Issued / Revised		
No.	Date	Description
1	8-9-17	ISSUED FOR BIDDING & PERMIT
2	8-29-17	ADDENDUM NO. 3
3	6-30-18	ADD DOWNSPOUT @ N.E. CORNER OF BLDG
4	11-19-18	ADD RAMP IN SIDEWALK FRONT MUSEUM, ADD HC CURB RAMP, AND CATCH BASIN
5	11-20-18	ARTS GARDEN

Massillon Museum Expansion + Renovation

UTILITY PLAN

C-104

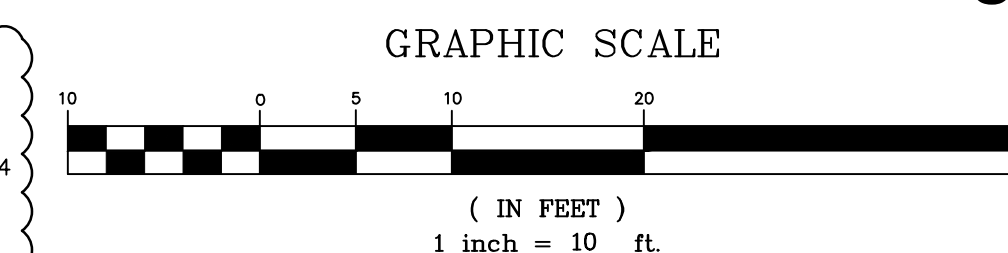
THE CONTRACTOR SHALL INSTALL 5 LF± OF 12" STORM SEWER BETWEEN NEW CATCH BASIN #1 AND THE EXISTING ROUND BASIN JUST TO THE SOUTH. IF THERE IS CLEARANCE WITH THE EXISTING DUCT BANK, IF IT IS NOT FEASIBLE TO INSTALL 12" STORM DESCRIBED ABOVE THEN CONTRACTOR SHALL CONNECT NEW CATCH BASIN #1 TO EXISTING 8" VCP USING PVC PIPE & FENCO COUPLING PER CITY OF MASSILLON REQUIREMENTS. RECONNECT 8" PVC DNP STORM FROM IN FRONT OF MUSEUM INTO CATCH BASIN #1.
